Technical Advisory Bulletin (TAB)

Bulletin #: TBBE1611B

Product: BERNINA E16

Subject: New Control Board

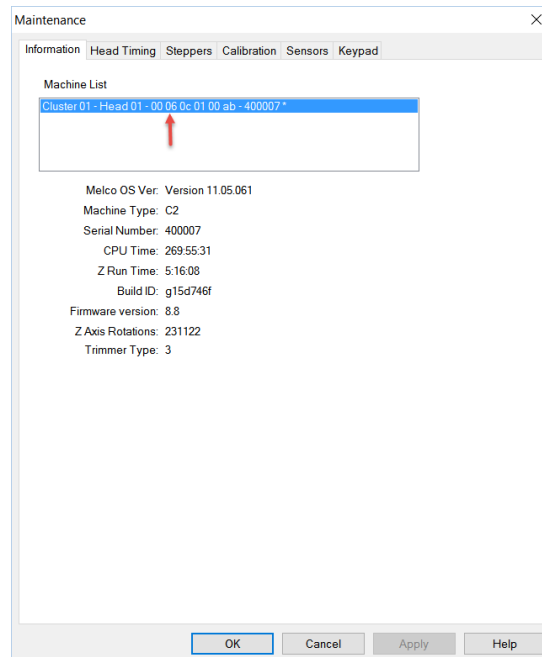
Calibration window for TBS has been hidden. This has been done due to the fact that factory calibration should be solid enough for the majority of the users.

To expose TBS calibration:

1. Computer\HKEY_CURRENT-USER\SOFTWARE\BERNINA\MC\Settings
 2. Create a new DWORD (32-bit) Value
 3. Name = ShowTBS
 4. Value 1 = on
 5. Value 0 = off
- 5) **Homing Frame:** New Control Board homes both X and Y axes at the same time.
 - 6) **Trimming:** New Control Board has a slightly different behavior during the trim sequence. This is mainly due to the way all motors work with the new Control Board and how the new firmware processes all the steps involved. The difference is mostly in how quiet/smooth the grabber moves in and out.
 - 7) When exiting the timing window in **maintenance mode** the machine no longer beeps. There has been user feedback that this was not needed.
 - 8) In **Maintenance** pressing speed  + Left  will take the Z-Axis to 120° which is just above the Needle Plate hole. This is a good placement for Needle Plate adjustment.
